**SUBJECT: 072112 PCT STRAD BAY ROOF AND HUSKY MAINTENANCE TOWER ROOF REPLACEMENTS**

**Responses to Bid Questions # 02**

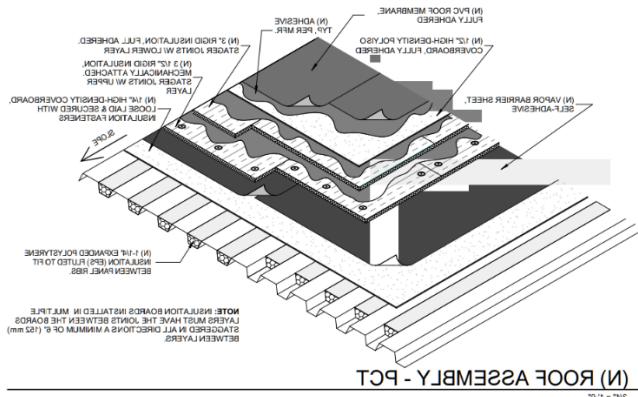
- 1) will get you an e mail from my rep stating that Duro-Last meets or exceeds the proposed product.
- 2) Will the roofing be removed on either building or not?
- 3) At the bid walk we were told it won't, but the plans are saying it will.
- 4) I see décor ribs are to be installed. What is the purpose of this? These roofs are not visible from the ground.

- 5) what is the purpose of raising the ladder? Does it mean temporarily raise it to change the coping metal?
- 6) Why are we using fleece backed material? This costs more and has no benefit. This is usually used when glueing over torch down roofing.

1. The demolition at the PCT Strad Bay roof area consists of the removal and disposal of the existing standing seam metal roofing panels. Expanded Polystyrene (EPS) Insulation will be fluted to fit into the underlying metal deck ribs, per Detail 2 on Sheet A1.10. See Details 3 & 8 on Sheet AD9.10 to reference metal roof panels to be demolished. See Detail 5 & 6 on Sheet AD9.10 to reference underlying metal deck to be fluted with EPS insulation (as viewed from the bottom).

2. Demolition of the roofing panels is not part of the scope of work at Husky.
3. Contract documents take precedence over any discussions held during the pre-bid walk unless formally modified in writing through addendum.

4. Decor ribs have been removed from the scope of work per Addendum No. 1.
5. The Roof Access Ladder at PCT will be permanently raised to accommodate depth of the new roofing assembly. Refer to details 8/AD9.10 and 10/A5.10.

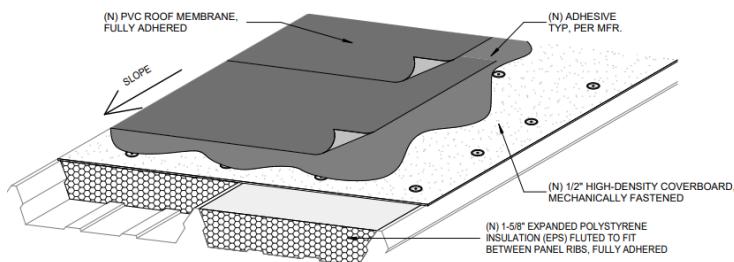
There are conflicting drawings. On A1.10 I see the roof assembly for PCT described as shown here.

Roof assemblies are not conflicting, they are different for each building – refer to the drawings. PCT roof details are shown on drawing sheet A5.10, with Husky roof details on sheet A5.20. There are no parapet walls on the structure, ladder modifications are required to suit the depth of the new roof assembly at PCT per detail 10/A5.10.

**(N) ROOF ASSEMBLY - HUSKY**

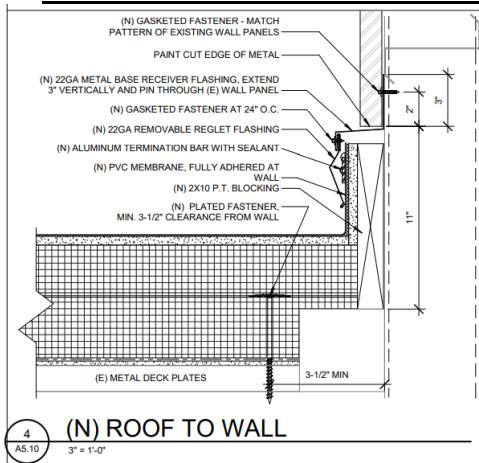
And on A1.20 I see Husky showing as this.

**Please clarify this. Also need to know why we are installing insulation on the parapet wall and cutting the ladder to extend it. This is not necessary. Please advise.**
